ASSESSMENT REPORT

GUNLAKE QUARRY Quarry Expansion Modification (MP 07 0074 MOD 2)

Figure 2: Existing site layout and surrounding residences

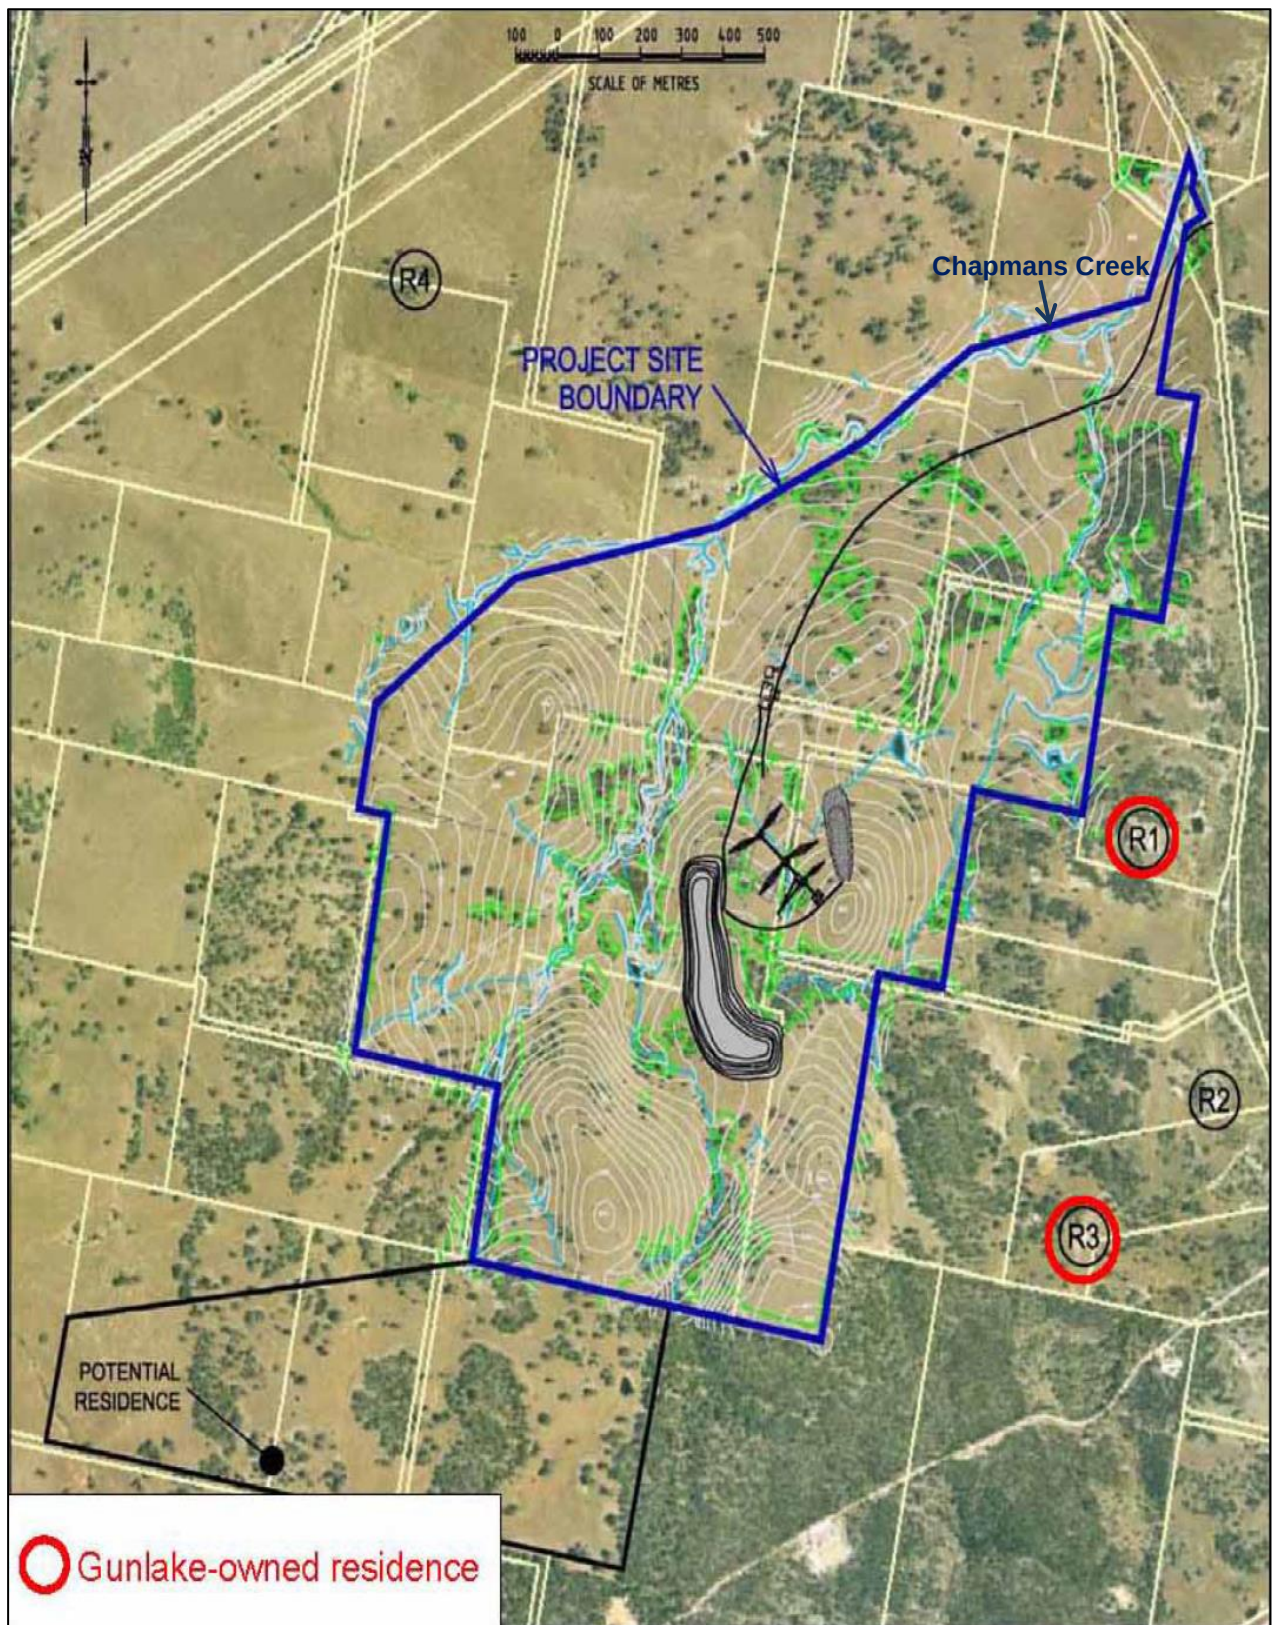
The quarry is located within a rural area on Brayton Road. As shown on **Figure 2**, there are 2 privately-owned residences (R2 and R4) located within 1.4 km of the quarry's operational areas. The closest privately-owned residence to the modified operations is R2, located approximately 700 m from the proposed overburden emplacement area.

The assessment predicted that there would be no exceedances of the EPA's air quality impact assessment criteria for PM_{2.5}, total suspended particulates (TSP) or dust deposition at any nearby privately-owned residence for either the modified quarry operations or total (ie cumulative) emissions. However, the assessment predicted an exceedance on 1 day per year of the cumulative 24-hour average PM₁₀ assessment criterion of 50 µg/m³ at a residence owned by Gunlake (R1, see **Figure 2**).

Figure 4: Approved Transport Routes

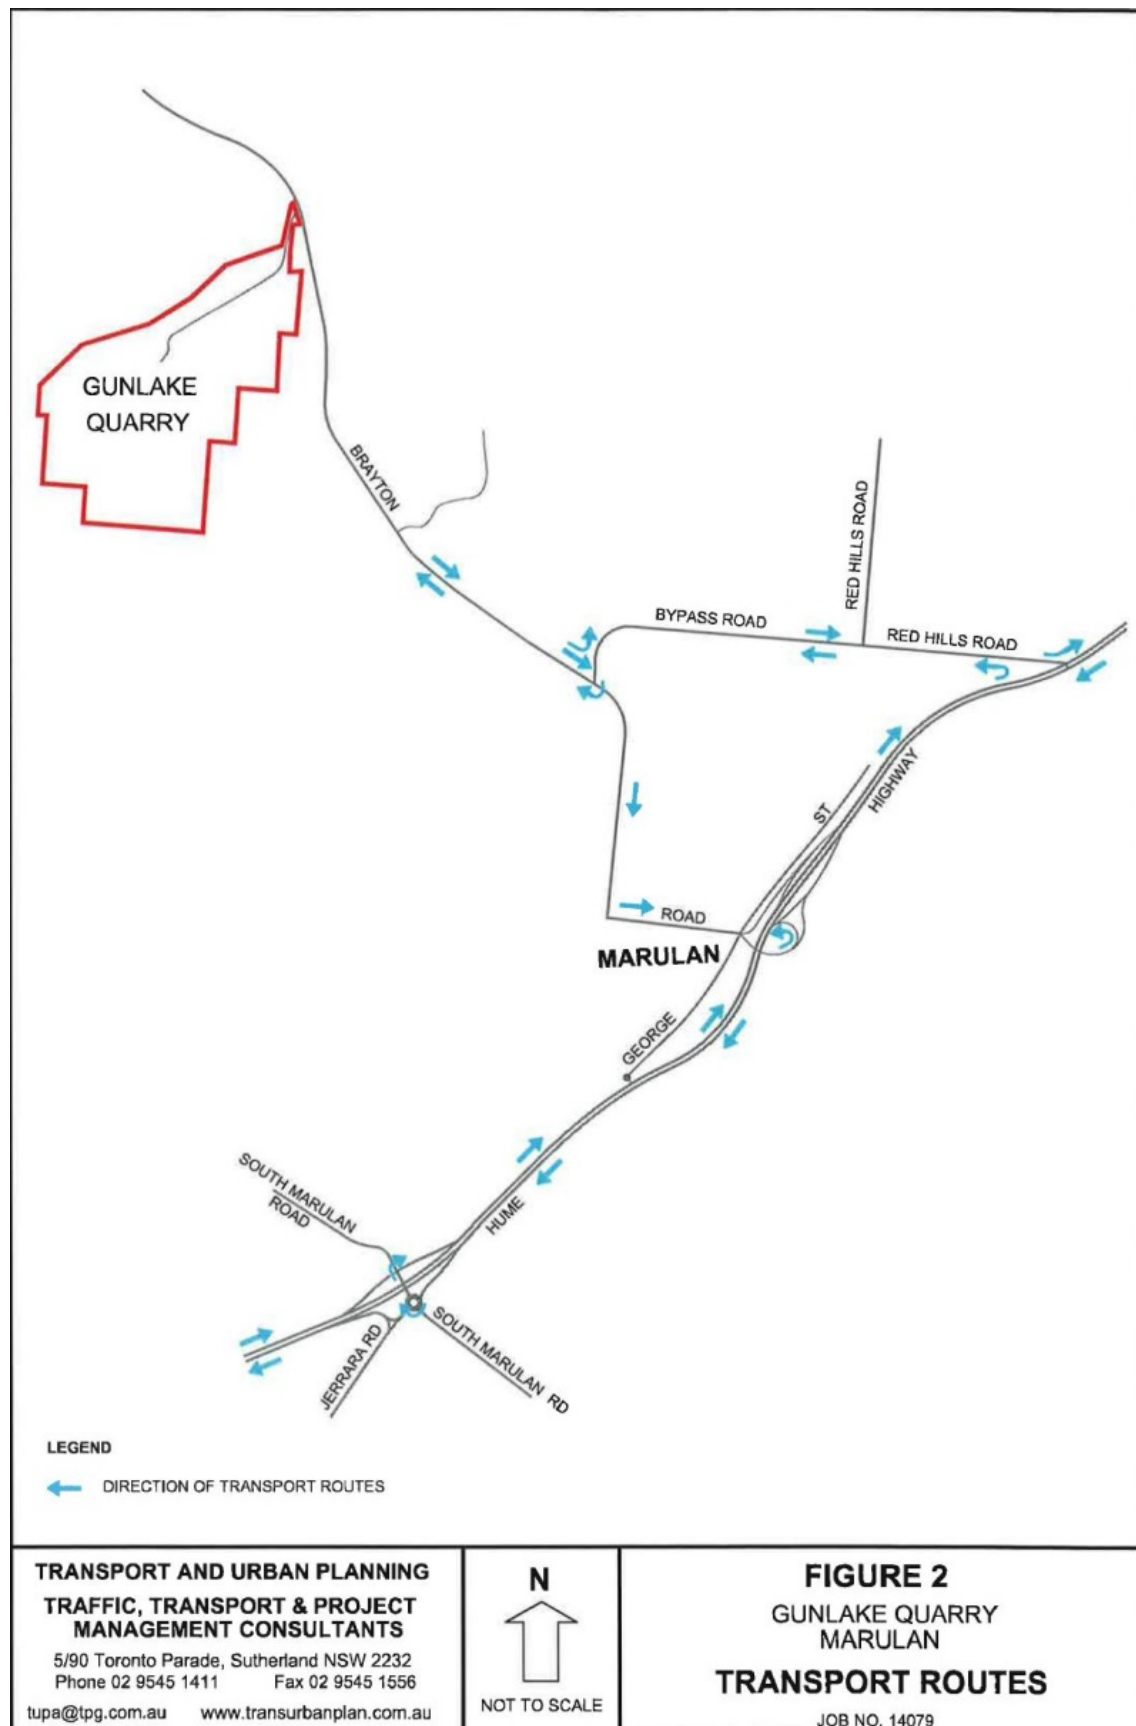
Loaded vehicles destined for markets south of the quarry travel along Brayton Road to the Hume Highway Interchange at South Marulan (the “South Marulan Interchange”). They then access the south-bound lanes of the Hume Highway through the interchange. When these vehicles are returning to the quarry, they proceed through the interchange and make a left hand turn onto Red Hills Road and access the quarry via the bypass road and Brayton Road (see **Figure 4**).

However, RMS considered that the proposed increase in the peak number of truck movements along the bypass road (ie an increase from a maximum of 150 to 320 truck movements/day) could potentially result in increased delays and safety issues with trucks entering the Hume Highway from the bypass road. RMS requested that additional observations should be undertaken to verify the current performance (specifically, delays) at the intersection of Red Hills Road and the Hume Highway.

The Department also notes that a considerable buffer exists with respect to the performance of this intersection, as the sensitivity testing documented in the RTS indicates that average vehicle delays would be in the order of 15 seconds per vehicle, which still represents a very good operation and relatively low vehicle delays. By way of comparison, LOS C is still a good level of service (vehicle delays up to 42 seconds).

The Department is therefore satisfied that the traffic assessment (which includes detailed SIDRA modelling) is adequate and the proposed modification is unlikely to result in significant delays and/or cause safety issues for quarry trucks entering the Hume Highway from Red Hills Road. Notwithstanding, the Department notes that the quarry would be required to update its Traffic Management Plan to reflect the proposed modification in consultation with RMS. The Department expects that this plan would describe measures to be implemented by Gunlake to avoid dispatching large groups or convoys of trucks via Red Hills Road onto the Hume Highway during peak periods.
